UNITED STATES PATENT AND TRADEMARK OFFICE

Office Action Summary	Application No. 10/505,253	Applicant(s) RASA ET AL.	
	Examiner Jason Prone	Art Unit 3724

DETAILED ACTION

Appendix A

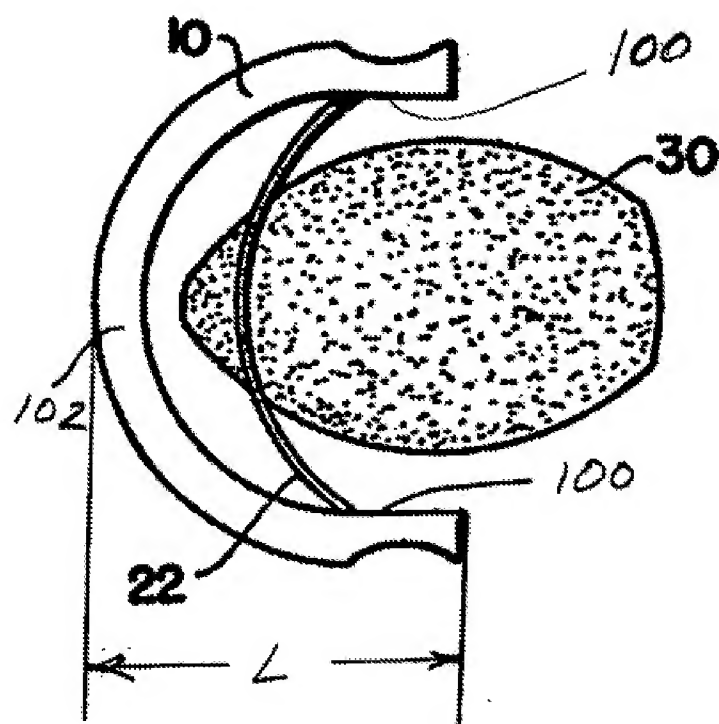
Claims 35-43, 47, 49, and 51 are rejected under 35 U.S.C. 103(a) as being unpatentable over Neveu (3,961,418) in view of De Vault (2,106,796). Please see Appendix A for examiner added reference numerals to Neveu.

In regards to claim 35, Neveu discloses the same invention including a peeler for peeling in a peeling direction (Title) comprising two lateral gripping surfaces (100) interconnected by a blade (22) and by a cross-piece (102), wherein the two lateral surfaces together with the cross-piece for a substantially U-shaped holder (Fig. 2), and the peeler being shorter in the peeling direction than a distance between the lateral surfaces at the peeling blade (See Appendix B, the Peeling Direction is labeled PD and the dimension of the peeler along line PD is clearly less than the spacing between gripping surfaces 100).

Also, Neveu fails to disclose the distance between the lateral gripping surfaces at the peeling blade is larger than a length and height of the peeler. Looking at Appendix A, it would have been obvious to shrink the “L” dimension to accommodate a hand with shorter fingers. It is old and well known to experiment/try larger and smaller size components since not everybody has the same sized/shaped body parts. It would have been obvious to one having ordinary skill in the art at the time the invention was made to have the distance between the lateral gripping surfaces at the peeling blade be larger than a length and height of the peeler, since it has been held that where the general conditions of a claim are disclosed in the prior art, discovering the optimum or workable ranges involves only routine skill in the art. *In re Aller*, 105 USPQ 233. Also, it would have been an obvious matter of design choice to have the distance between the lateral gripping surfaces at the peeling blade be larger than a length and height of the peeler, since such a modification would have involved a mere change in the size of a component. A change in size is generally recognized as being within the level of ordinary skill in the art. *In re Rose*, 105 USPQ 237 (CCPA 1955). Therefore, it would have been an obvious matter of design choice to modify the device of Neveu to obtain the invention as specified in claim 35. The claim would have been obvious because a person of ordinary skill has good reason to pursue the known options within technical
